# Service Bulletin

Bulletin No.: 19-NA-094

**Subject:** Ticking Type Noise Heard from the Driver and/or Passenger Side Center Pillar Upper Trim Panel Structure On Bumpy Roads

5330277

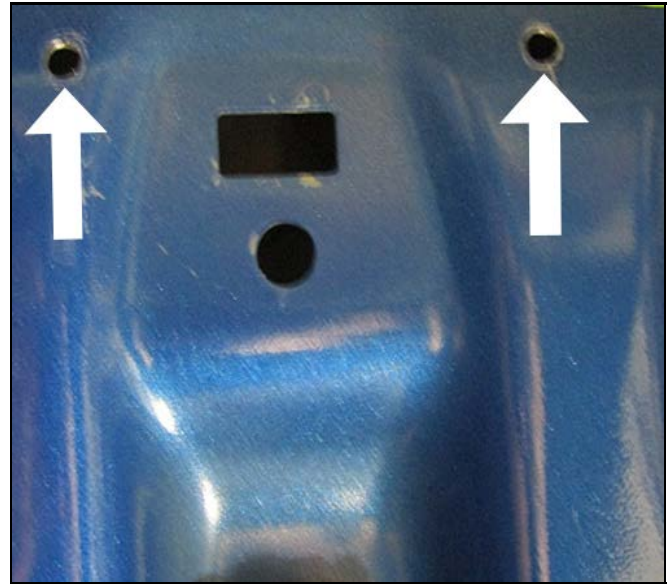
4. **For Drivers's side:** From the right side upper corner of the clip square hole, measure right 42 mm (1.65 in) (3) and up 9 mm (0.35 in) (4) and with a paint pen mark both locations, as shown in the graphics above.

**For Passenger side:** From the right side upper corner of the clip square hole, measure right 24 mm (0.94 in) and up 7 mm (0.27 in) and with a paint pen mark both locations.

5322317

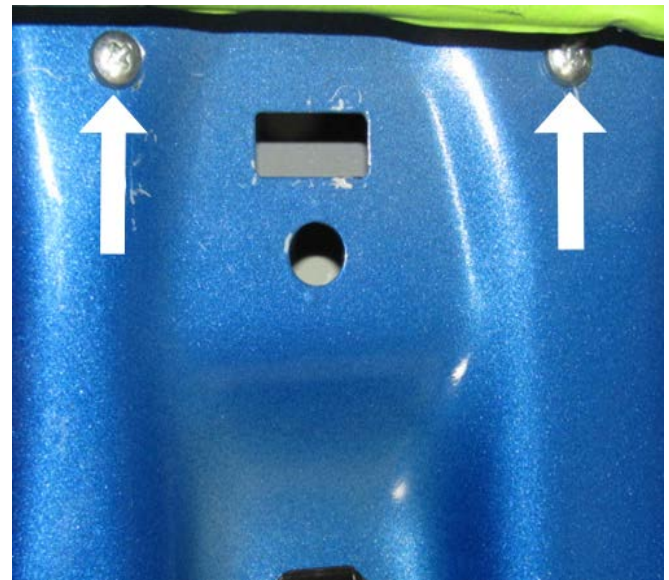
**Important:** BEFORE drilling, tape the 11/64 drill bit, as shown in the graphic above, so only 30 mm (1.18 in) of the bit is exposed to avoid drilling through additional layers.

5. Drill two pilot holes through two layers of the metal using a 11/64 drill bit, as shown in the graphic above.
